Subject: Collin County Healthcare Facility, Parking Garage, and Medical Examiners
PCO No. 126; RFI #397 ME Open Conference 115 Light and Diffuser Alignment Constraint

Issue No. 126 - RFI #397 ME Open Conference Light and Diffuser Cons
Amount
Item: I Medical Examiners

RFI #397: ME - Open Conference 115 Light and Diffuser Alignment Constraint

ME-E3.01

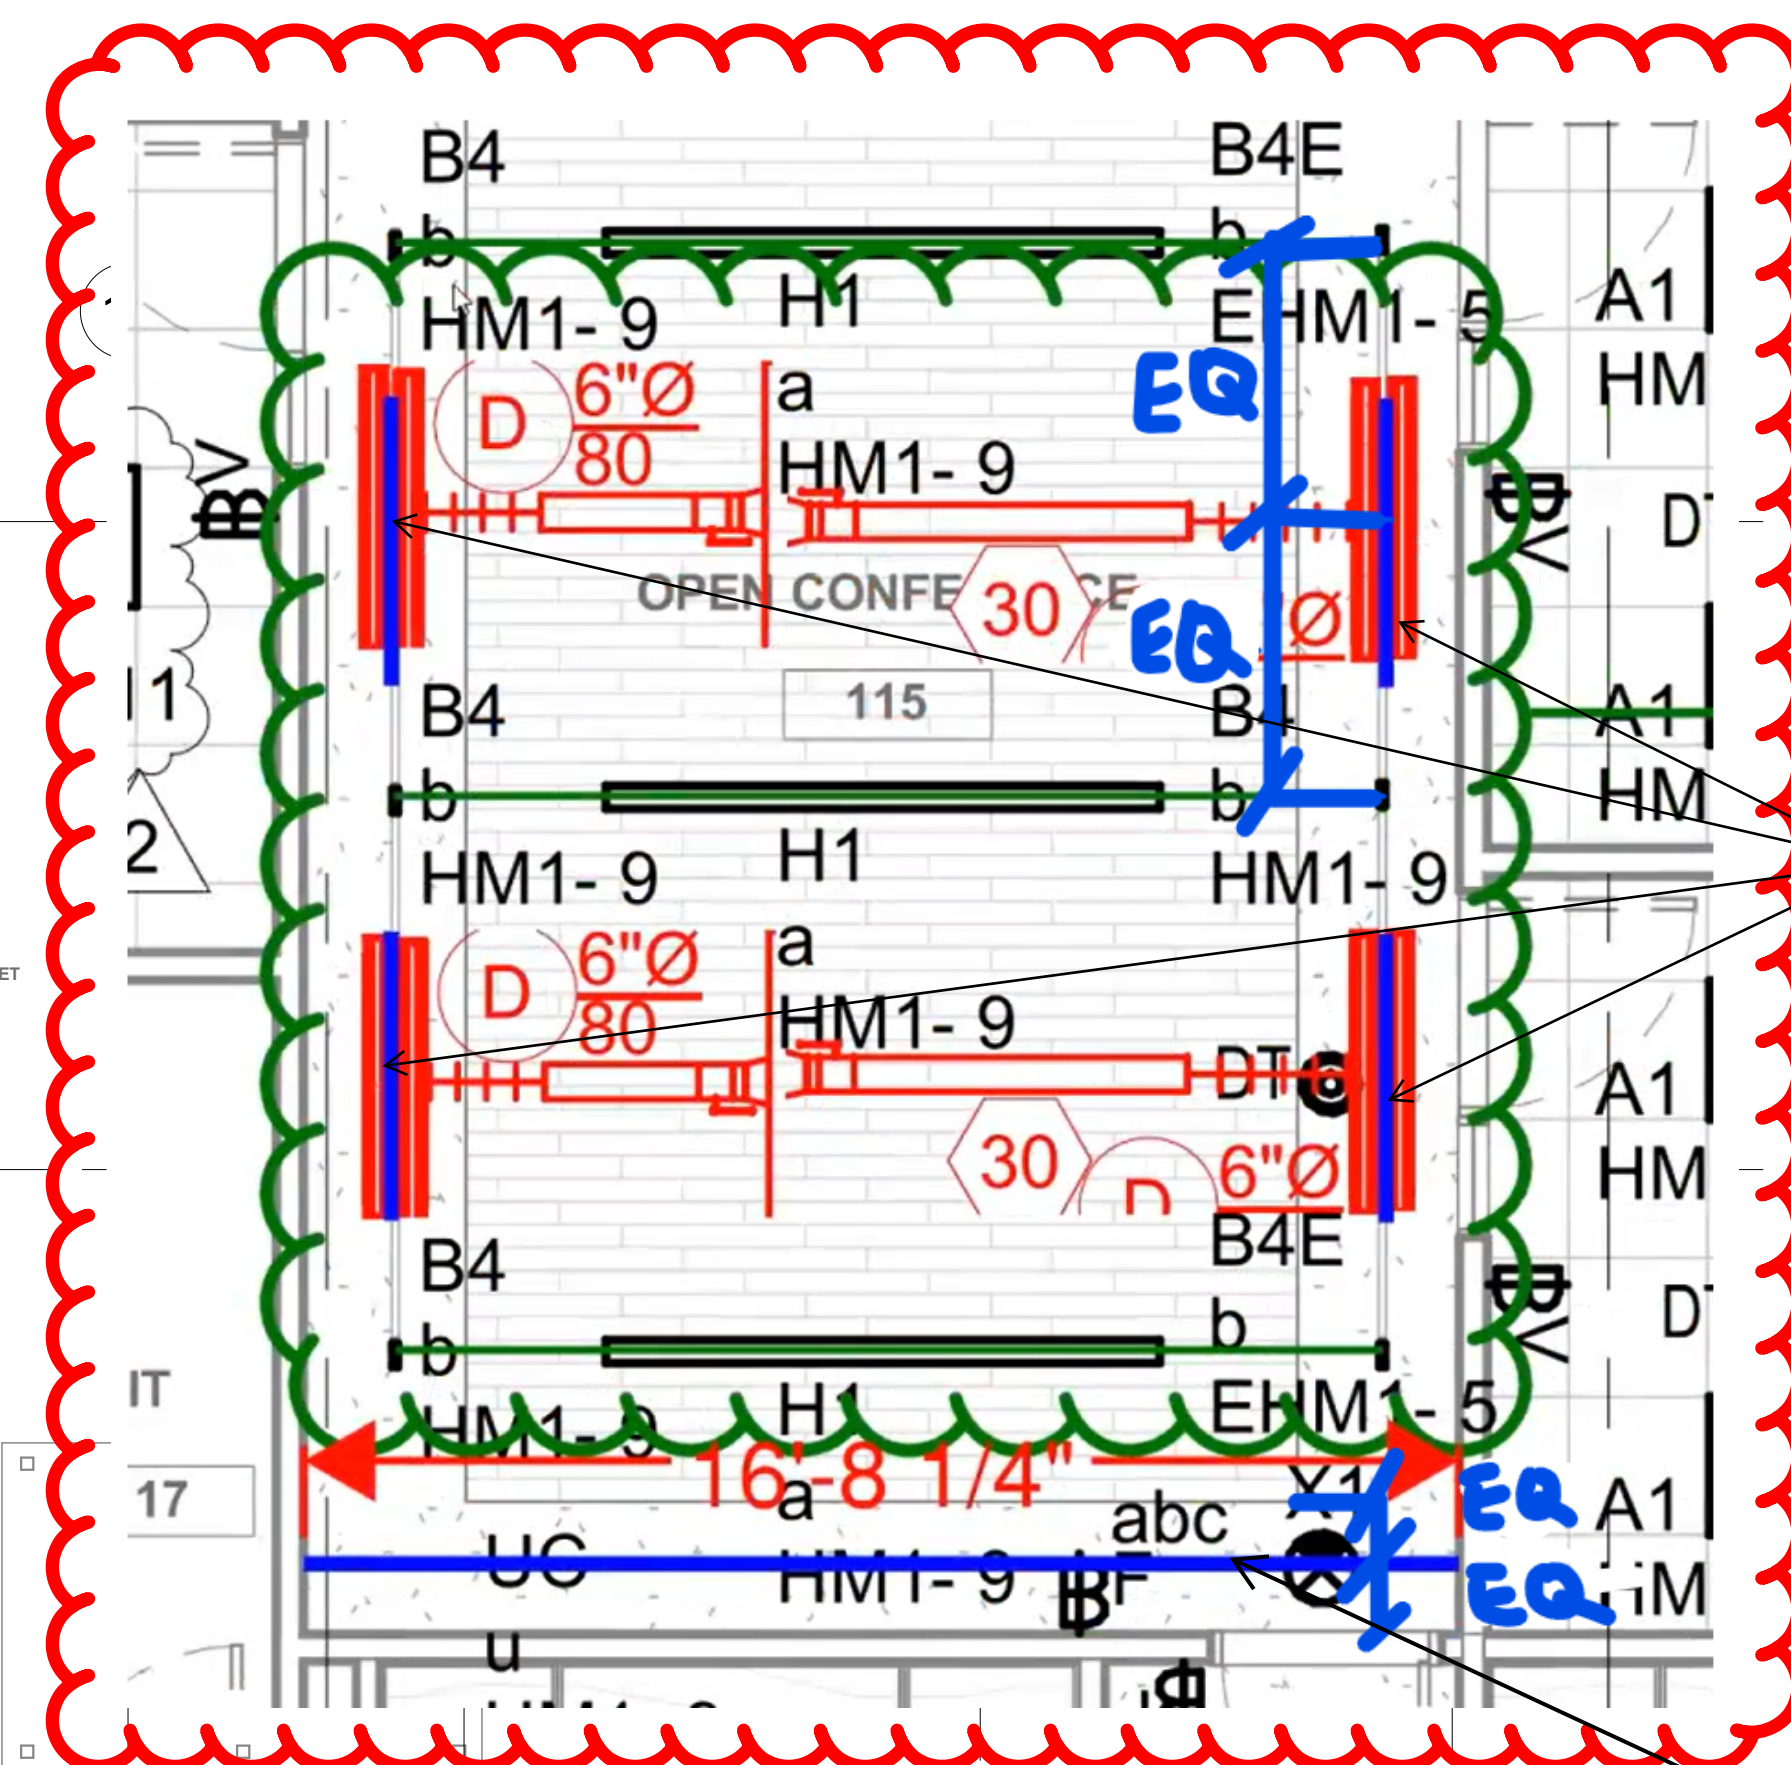
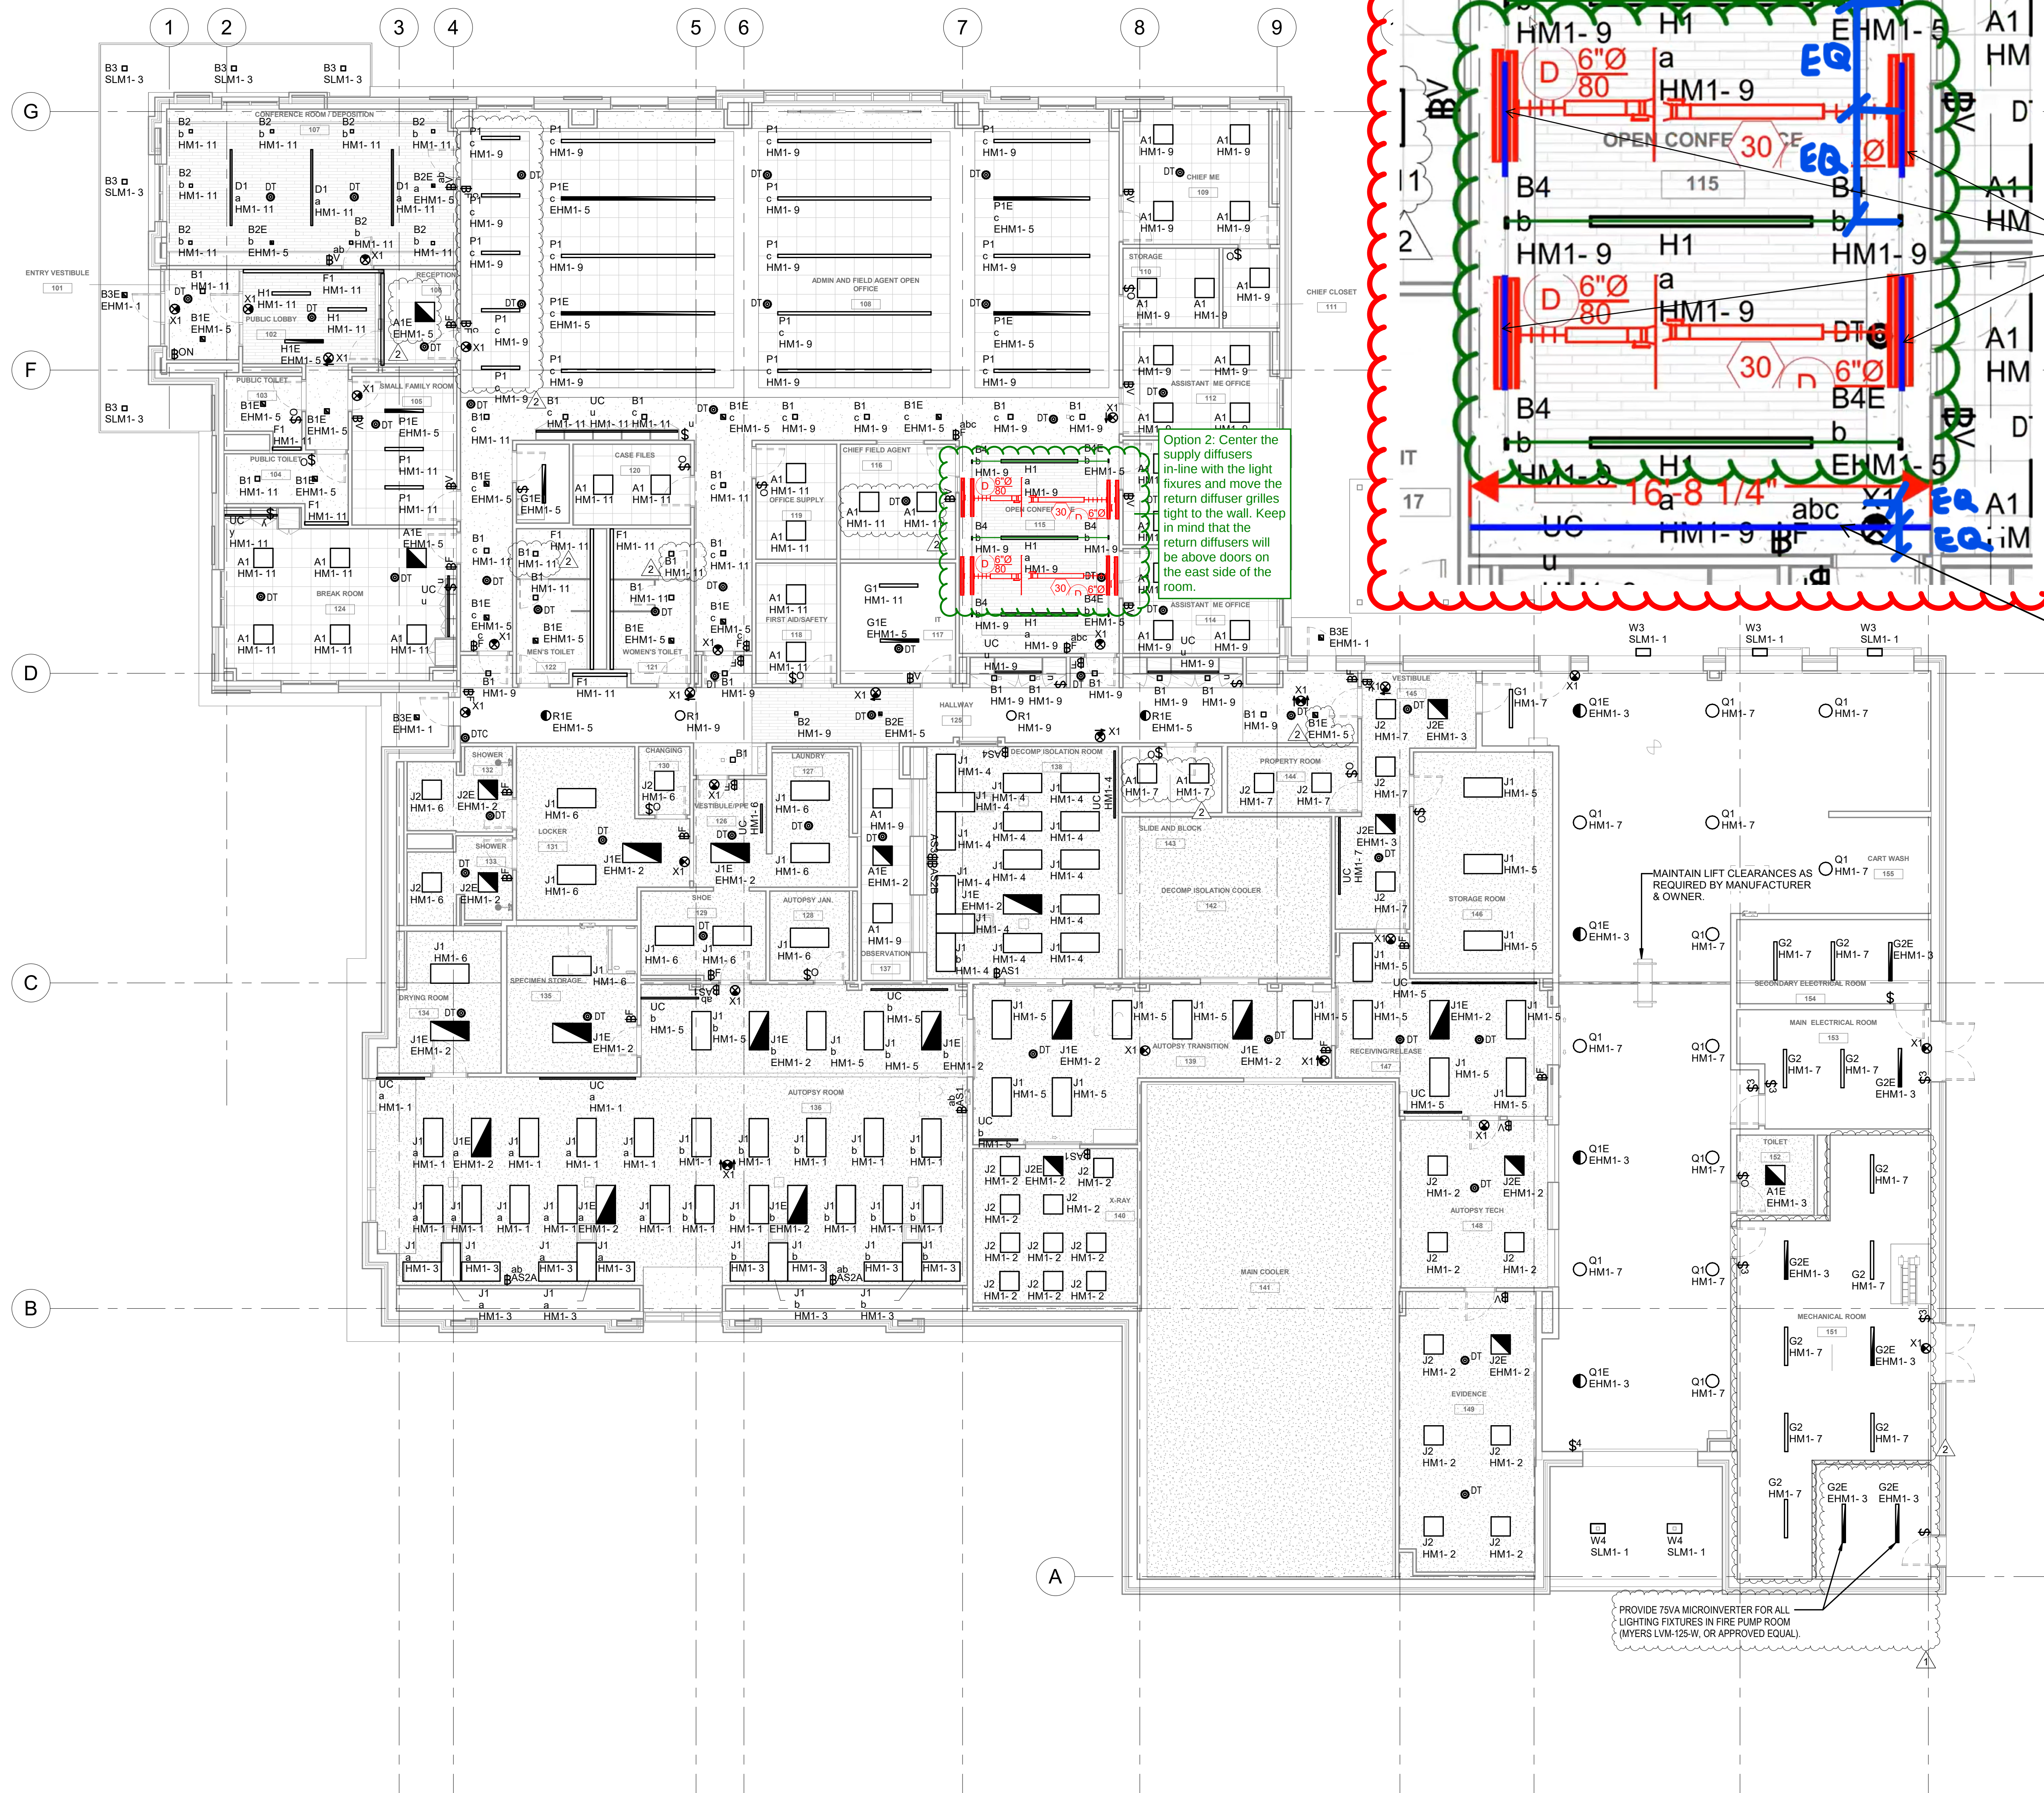
In the Open Conference Room 115, the drawings call for the lights and diffusers to be placed in-line, with the lights lining up with the light fixtures on the wood ceiling. After reviewing with our electrical and mechanical contractors, we have come to the conclusion that this is not feasible with the scheduled light fixtures and diffusers. The diffuser grilles are 4' in length and the light fixture mounts are 13"x9". The light fixtures on the hard ceiling (not wood ceiling), show to be 8'2" center-to-center. Due to the size of the lights, this will push the end lights out and will not keep them in line with the lights on the wood ceiling.

Keeping design intent in mind, the contractors propose two solutions.

Option 1: Move the return diffusers to the outside of the supply diffusers and split the difference, keeping the centerline of the lights in-line with the centerline of the two diffusers on each side(N-S Direction). This will maintain a line from diffuser to light and also maintain the line from light (E-W Direction) to light across the wood ceiling.

Option 2: Center the supply diffuser grilles on the line of light to light (N-S Direction) and move the return grilles tight to the wall on all sides. This will still maintain the line from light to diffuser to light (N-S Direction) while maintaining the line from light to light (E-W Direction) across the wood ceiling.

Markups are provided to detail proposed solutions.

Keep in mind that both options will require reframing of the locations for the grilles and light fixtures. keeping the locations of the diffusers the same will require reframing of the light fixtures.

Please advise on whether or not either of these is an acceptable solution and provide updated sheets or provide an alternate solution.

Option 2: Center the
supply diffusers
in-line with the light
fixtures and move the
return diffuser grilles
right to the wall. Keep
in mind that the
return diffusers will
be above doors on the
east side of the
room.

- **The scope of work includes reframing the diffuser and light locations in Open Conference Room 115 per RFI 397 response.**
 - **The supply diffusers will be positioned equal distance between the light fixtures running through the wood ceiling, and the return diffusers will be relocated to the soffit on the end of the conference room. All diffusers will remain fully within the gypsum board ceiling.**
- ***This PCO will be an add in the amount of \$2,533.00.***

Refer to the file attached for PGAL/Summit proposed solution

Proposed PGAL/Summit solution:
See in blue in the mark up below for proposed solution to the
supply and return diffusers layout.
